SOUTH PETERSFIELD RESIDENTS ASSOCIATION

Planning application reference: 21/00264/FUL

South Petersfield Residents Association continues to **object** to the revised application for the development on Cambridge station car park (blocks B2 and F2) on the following grounds.

Figure 1: Height of B2 (left) relative to F2 (right) – both to the same scale. The edifice of B2, as seen from the corner of Devonshire Rd, is 6 metres higher than the edifice of F2.

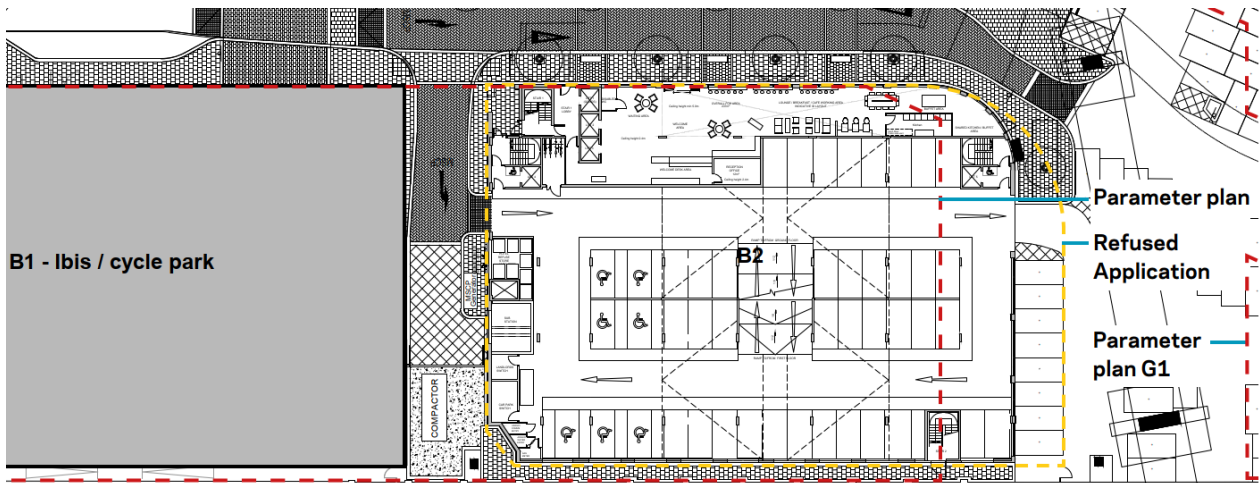
- 2) The applicant accepted the need to reduce the height of F2 significantly at the Devonshire Rd end to avoid creating an overbearing edifice. However, it has made only small

concessions in relation to B2, pulling it back 4.5m and stepping the top floor back. The edifice of B2 seen from the corner of Devonshire Rd (excluding the top floor and plant) is still 16m high, 6m higher than the edifice of F2 (see Figure 1).

Figure 2: Current proposed footprint of B2 compared with outline plan (in red) and refused application (in yellow)

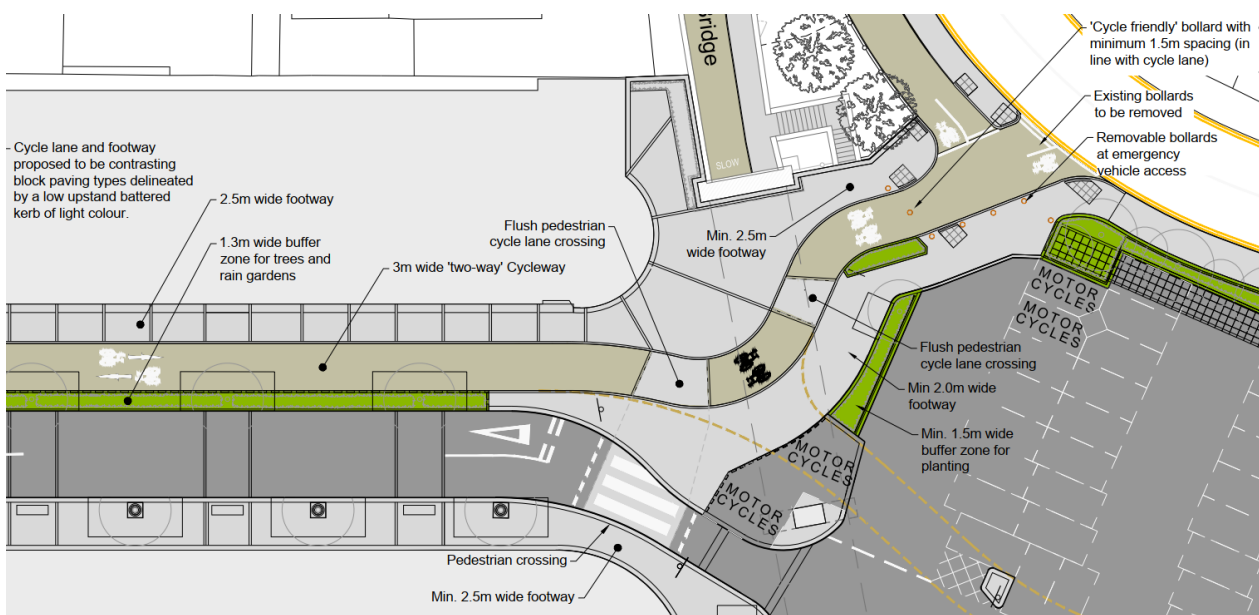
- 3) The footprint of B2 still extends 7m north beyond the footprint of the outline planning consent (see Figure 2). Combined with the height and mass, the building will be an overbearing neighbour to residents of Devonshire Rd and Devonshire Mews.

Figure 3: Proposed configuration of access from Devonshire Rd

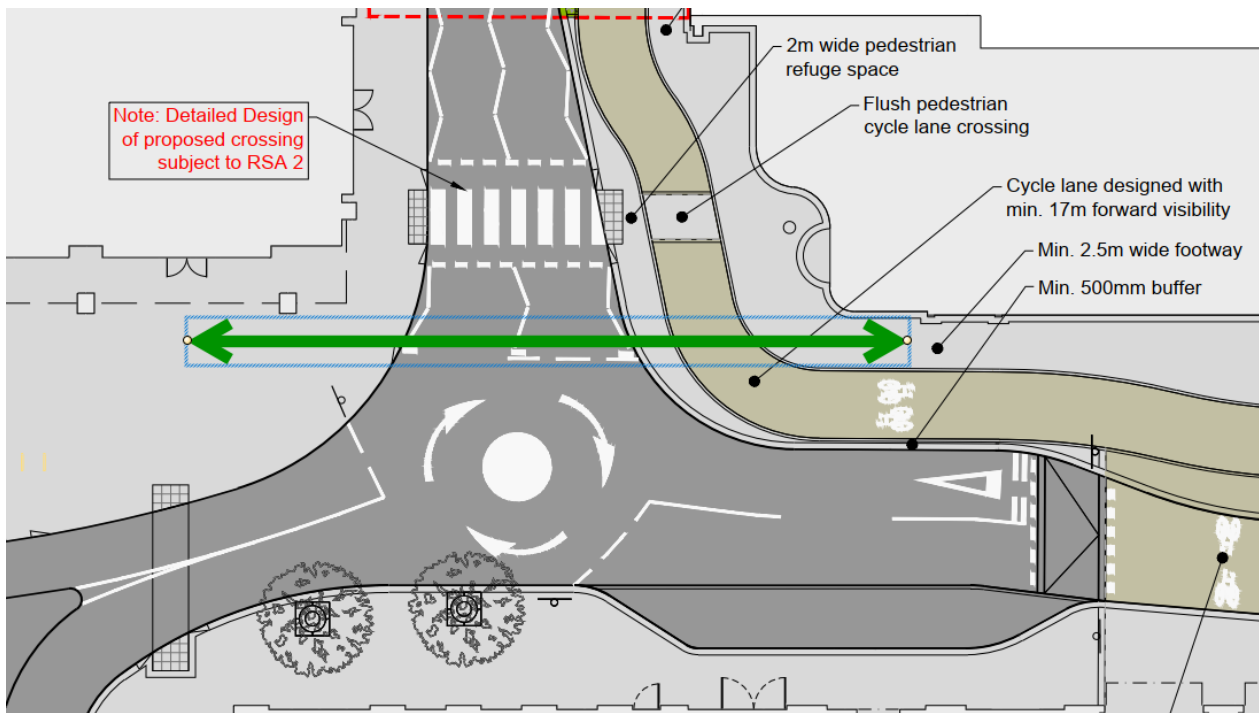
- 18) We are very pleased that the applicant has accepted our and Camcycle's recommendations to extend the northern footway under the Carter bridge (see Figure 3).
- 19) The pinch point in the footway along the west side of the Ibis café is exacerbated by the positioning of a lamppost and bollards (see Figure 10). This could be improved by affixing the lamp to the building or moving it to the other side of the Northern Access Road. We ask officers to include a condition on any planning consent to address this in the detailed design for this application.

- 20) We are pleased that the applicant will reinstate a planted screen along part of the north side of the footway (see Figure 3). We would like this to be extended as far towards Devonshire Rd as possible.

Figure 4: Proposed zebra crossing at east end of Great Northern Rd and pedestrian desire line (shown in green)

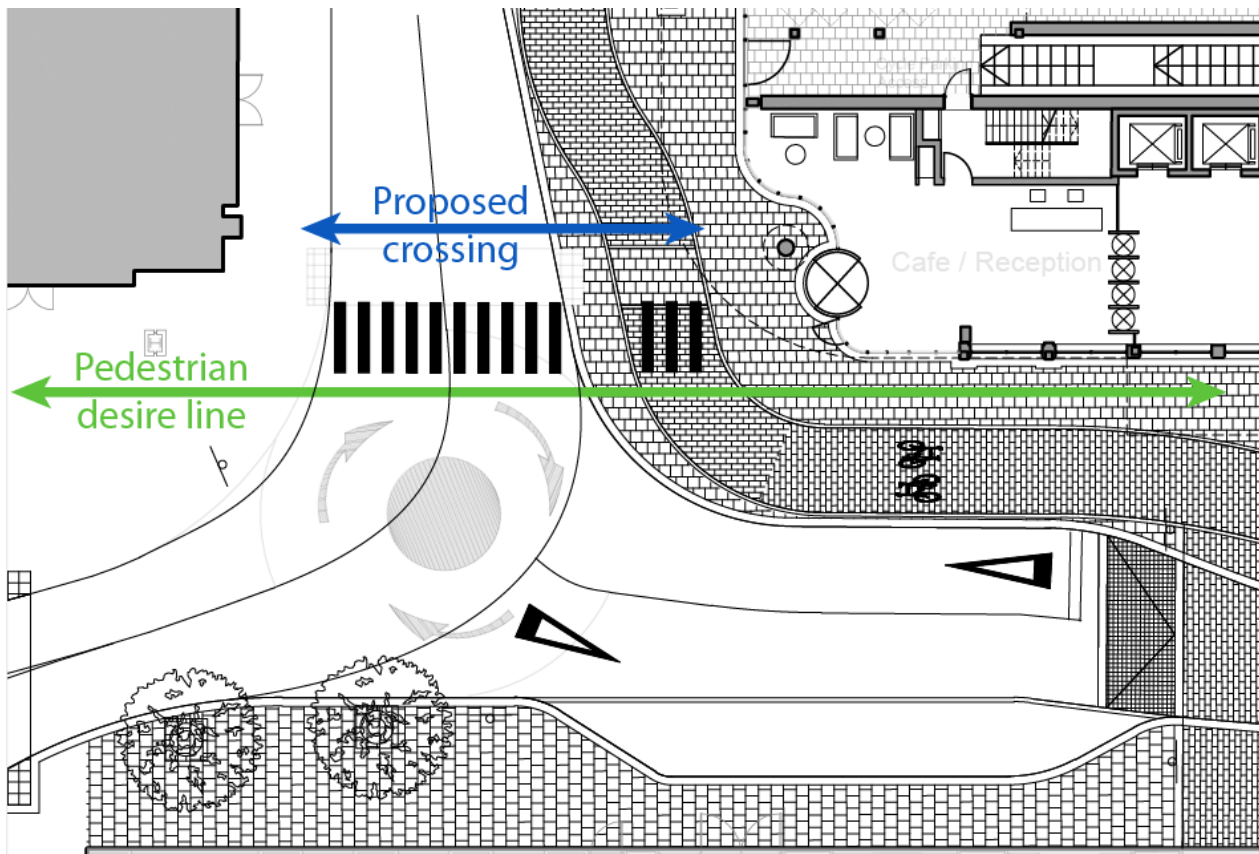
- 15) We are pleased that the applicant has accepted the need for a zebra crossing on the eastern end of Great Northern Rd. However, the crossing is now further off the desire line than the current informal crossing. (Note that the current crossing aligns with the lane through the car park; in future the pedestrian route will be in front of F2 – see Figure 4.)

Figure 5: Suggested configuration of junction between Great Northern Rd and Northern Access Rd

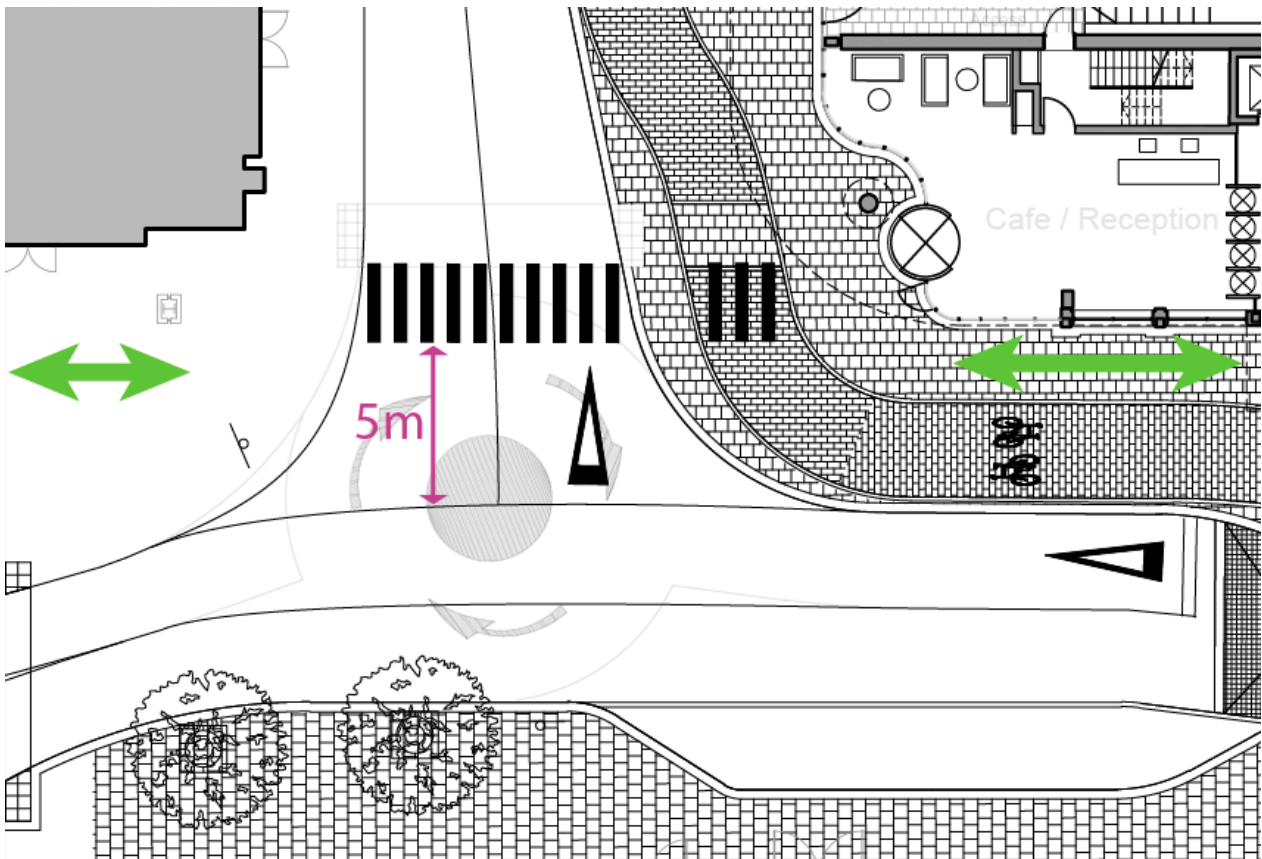
- 16) Two alternative configurations suggested (see Figure 5 and Figure 7), which could potentially allow the crossing to be significantly closer to the desire line, and avoid congestion on the corner outside Sainsbury's.
- 17) The argument given by the applicant against doing this is that vehicle speeds could make this unsafe. The answer is not to inconvenience people walking, but rather to ensure that vehicles do not exceed a safe speed when exiting the station square. This can be achieved by, for instance, tightening the corner radius. Visibility is good as there are no structures obscuring drivers' view of pedestrians approaching either side of the pedestrian crossing (see Figure 8).

Figure 9: Access arrangements during construction of B2

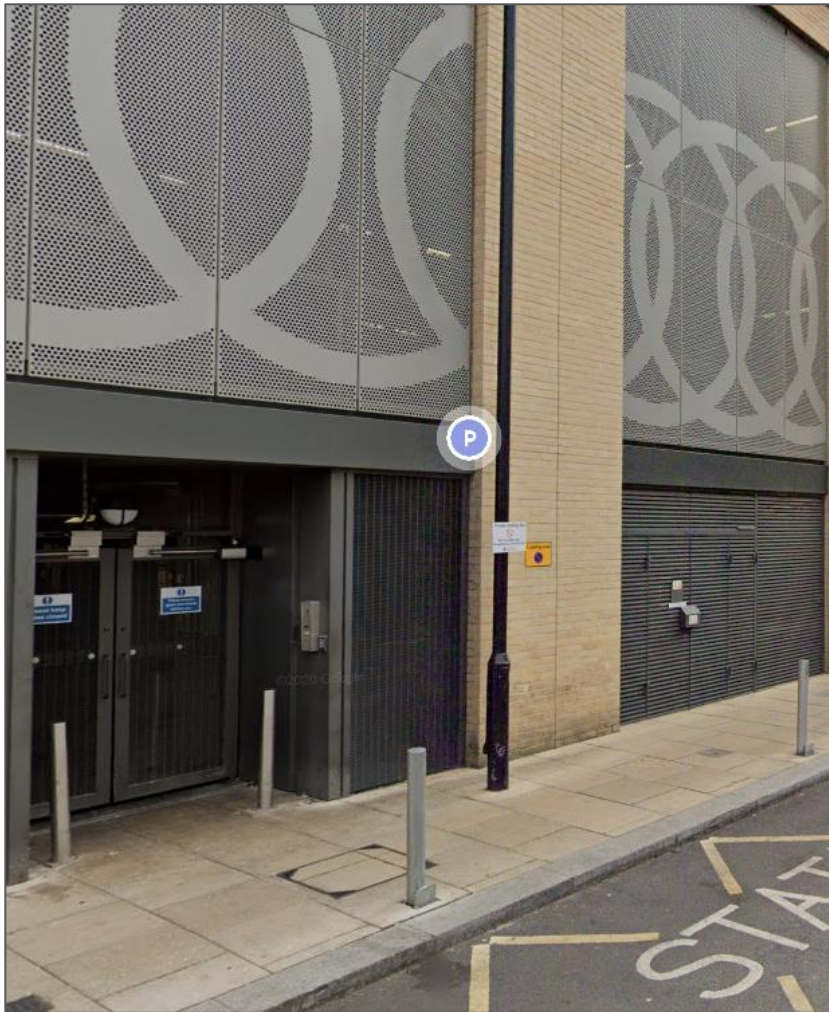
- 23) The access arrangements during the construction of B2 (see Figure 9) need to address in more detail:
 - How will people cycling access the Cyclepoint when construction vehicles are entering or leaving the site compound? There could be significant delays when large vehicles are manoeuvring.

- How will the road outside the Cyclepoint will be kept clear of mud.

- The drawings show no pedestrian crossing points from the footway on the north-west corner of the mini-roundabout to the south (to replace the crossing that will be temporarily removed to create car access to the car park) or to the east.
